Kansas Department of Agriculture
 Division of Water Resources
CHANGE: P/D WORKSHEET

DWR FIELD OFFICE APPLICATION FOR APPROVAL TO CHANGE THE PLACE OF USE AND/OR THE POINT OF DIVERSION

SUMMARY ORDER APPROVING APPLICATION FOR CHANGE AND IMPOSING CONDITIONS

Evaluation of proposed move for Water Right No. 10841 D1

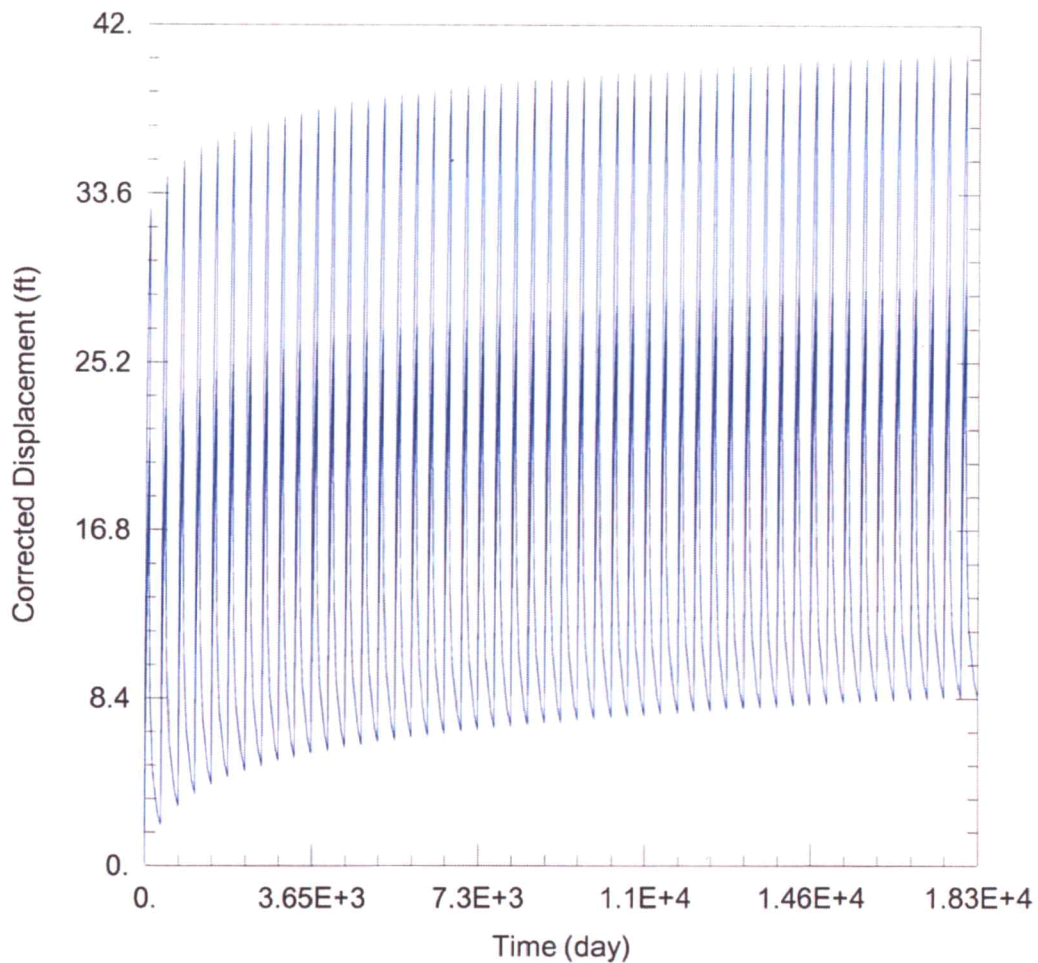
The proposed change is located near an area with a prior impairment investigation. During this investigation, a pumping test was conducted in 2009, and the specific yield (S) and transmissivity (T) values used to determine well-to-well drawdown effects were drawn from the results of that pumping test. These values are considerably lower than much of the high plains aquifer, and as a result, the calculated well-to-well drawdown effects are very large, and dynamic drawdown requirements (the depth a local well draws into the aquifer to access the water it is currently using) are also very high.

All wells with certified water rights in the area were found to be critical, meaning they are likely to be impaired. In some cases, the total drawdown effects over the next 25 years, when aquifer decline and dynamic drawdown requirements are considered, are estimated to exceed the remaining saturated thickness. These large declines are not actually possible. Instead, the proposed well will likely be incapable of pumping its full annual rate and quantity, and neighboring wells will experience drastic declines in well productivity due to the inability to draw as deep into the aquifer to access a water supply.

Given the information available, it is difficult for GMD3 staff to recommend approval of the application. It is possible that a local aquifer test may prove this area to be different than the location tested in 2009. Better data may provide different results and recommendation. It is also possible that the applicant may agree to a limitation of rate and quantity so that neighboring wells are not flagged as critical through this review process, though those reductions would need to be significant if the aquifer values used are

accurate. Neighbors with questions or concerns should contact GMD3 at (620) 275-7147 or the Division of Water Resources Garden City Field Office at (620) 276-2901 to put concerns on record. Otherwise, the application may be approved as is.

WELL TEST ANALYSIS

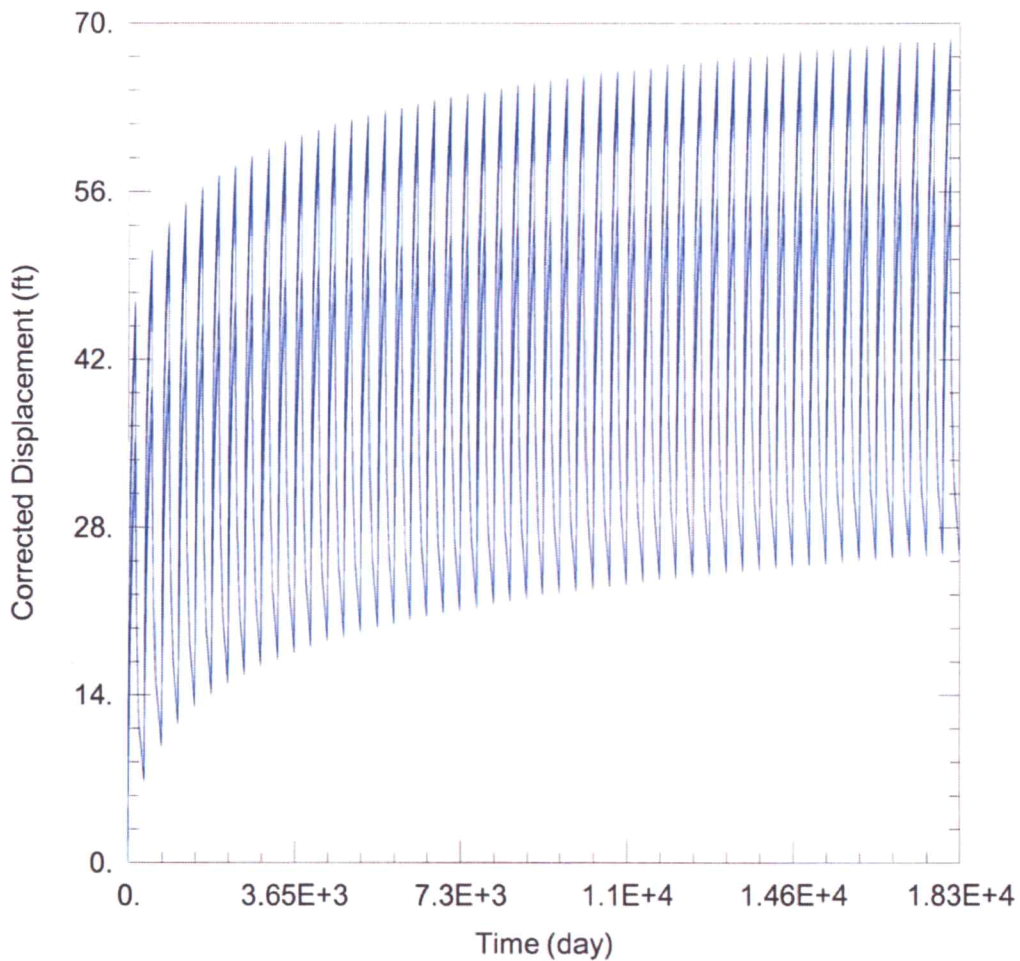
Wells within 1 mile: 44494, 30093, 13386, 42316, 10841 D2, and a domestic well in section 10-31-27.

| 44494: | Drawdown from current location = 26.3 ft |
| | Drawdown from proposed location = 67.3 ft |
| | Net drawdown = 41.0 ft |

Net drawdown exceeds the drawdown allowance of 4.0 ft for all wells within 1 mile of the proposed location. Critical well analysis is necessary on those wells.
